HERBATA DATA CENTRE, NAAS - RESPONSE TO REQUEST FOR FURTHER INFORMATION ("RESPONSE TO RFI") FROM KILDARE COUNTY COUNCIL

ADDENDUM TO CHAPTER 1 INTRODUCTION AND NEED FOR EIAR

NI2615
01
June 2025

Figure 1.2: Amended Overall Proposed Site Plan (extract of now submitted drawing 22217-RKD-ZZ-ZZ-DR-A-1010-OVERALL PROPOSED SITE PLAN)

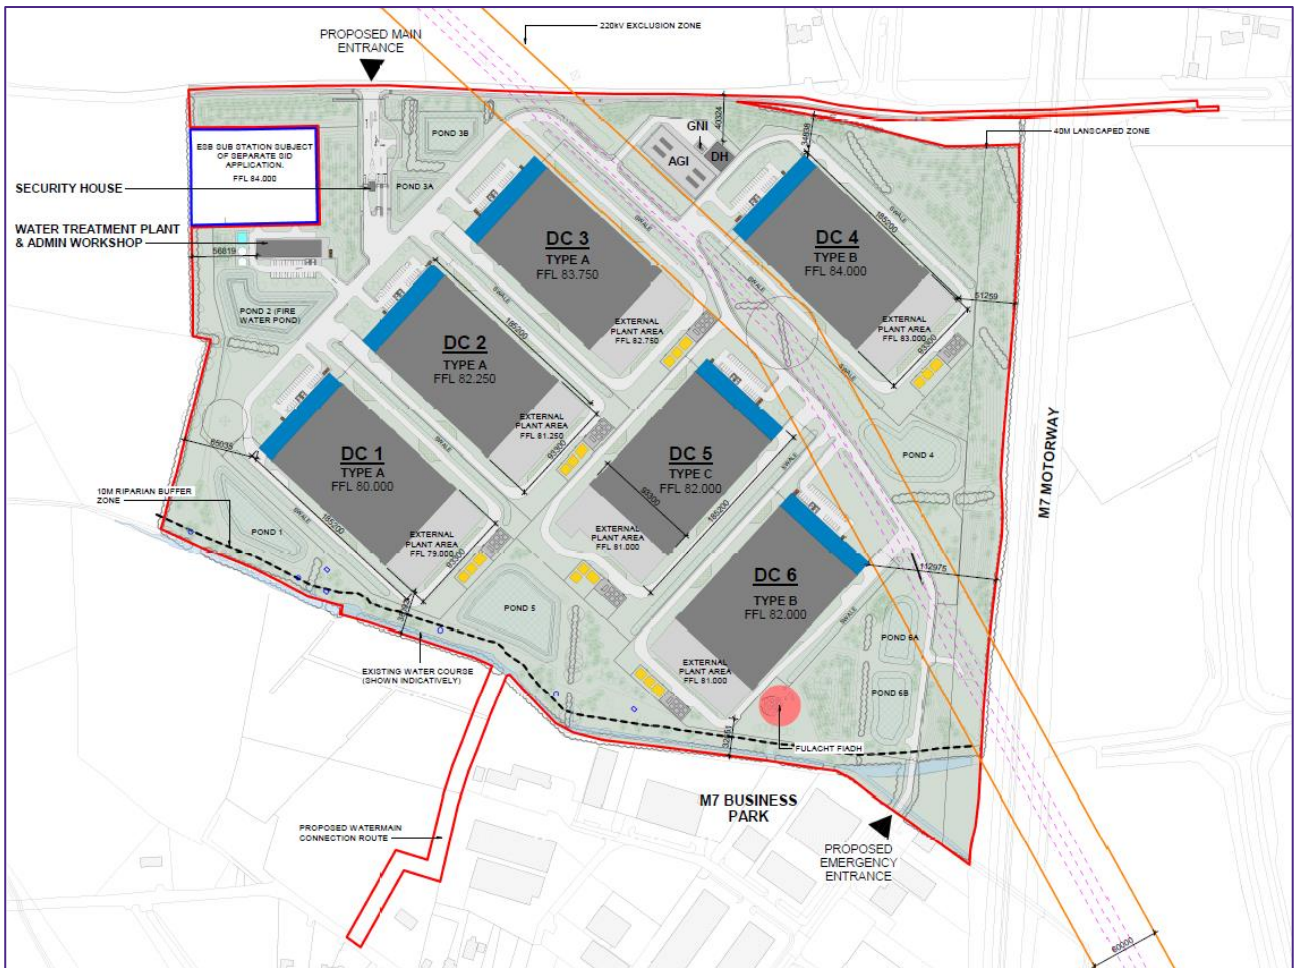
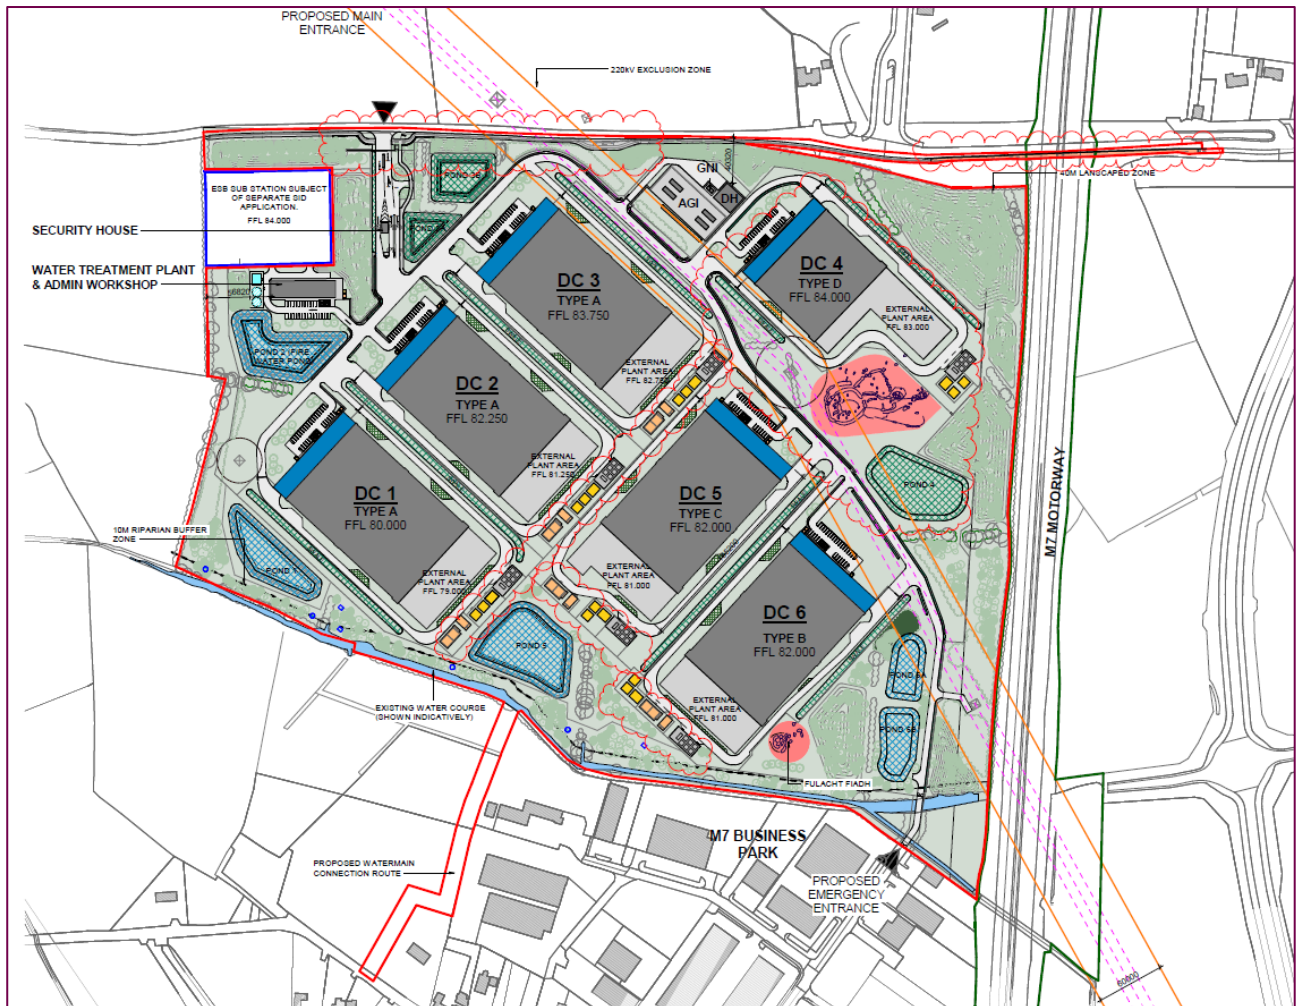
An amended design is proposed for Data Centre 4, primarily in respect of the arrangement of the proposed energy plant area (to the rear of the building) and subsequently, the overall plan of the building.

The amended design of Data Centre 4 is in response to the Kildare County Council RFI (Item 25) having considered the potential archaeological feature identified to the south east corner of the building; further detail and consideration of this is provided in the Addendum to Chapter 10 Cultural Heritage of the EIAR.

In order to accommodate the amended design of Data Centre 4 building, minor amendments to the layout of ancillary elements (such as security fencing, access road, drainage etc) which are within immediate vicinity of the building, are proposed. The component elements of Data Centre 4 (as summarised in Section 1.2 (a) above), the location within the overall site, building height, materials and finishes, remain unchanged.

Figure 1.4: Amended Proposed Site Plan (extract of now submitted drawing 22217-RKD-ZZ-ZZ-DR-A-1012-PROPOSED SITE PLAN B)

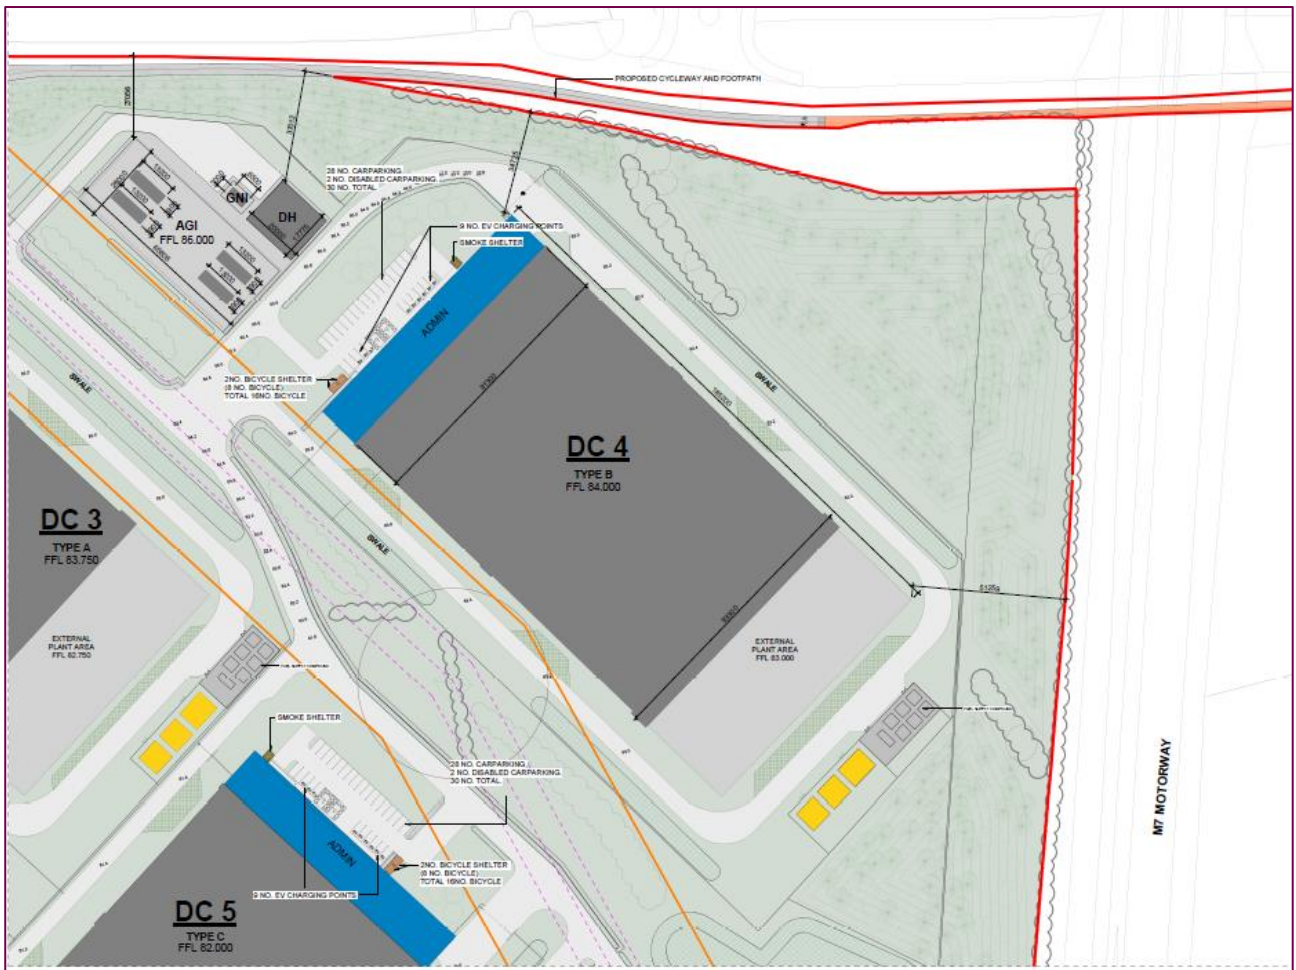
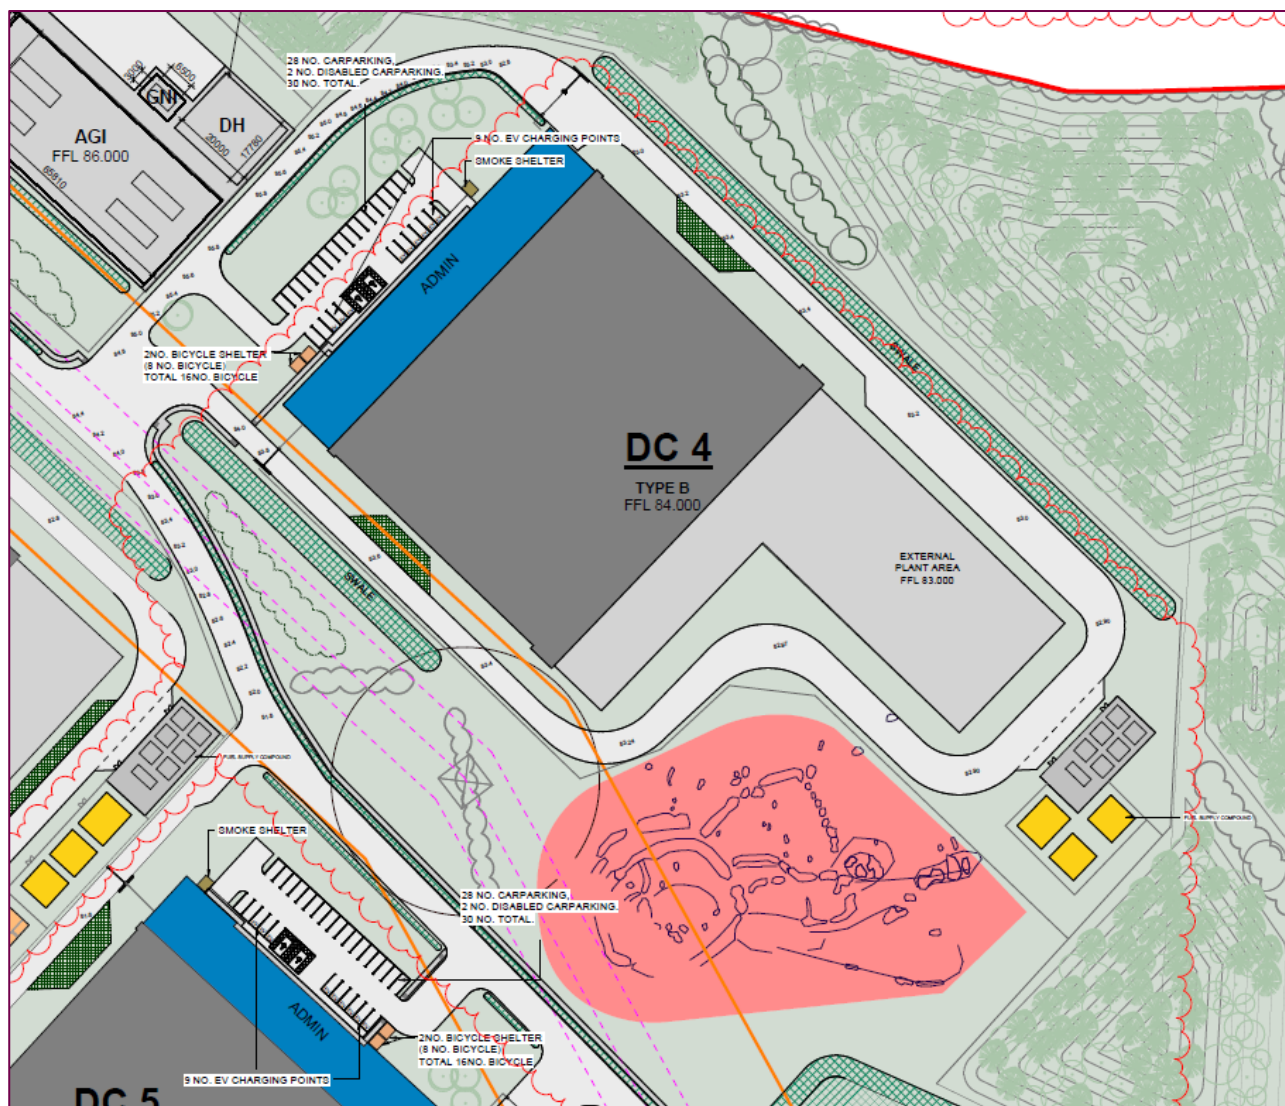
The external plant gantry and enclosed yard to the rear (encompassing the building energy infrastructure) of Data Centre 4 remains largely consistent with the description set out in the submitted EIAR however the arrangement of the energy infrastructure has been altered to reflect the amended building design.

Data Centre 4 will maintain the proposed solar photovoltaic (PV) arrays, located on the roof top albeit with a reduction in the number of panels, due to the amended design of the building.
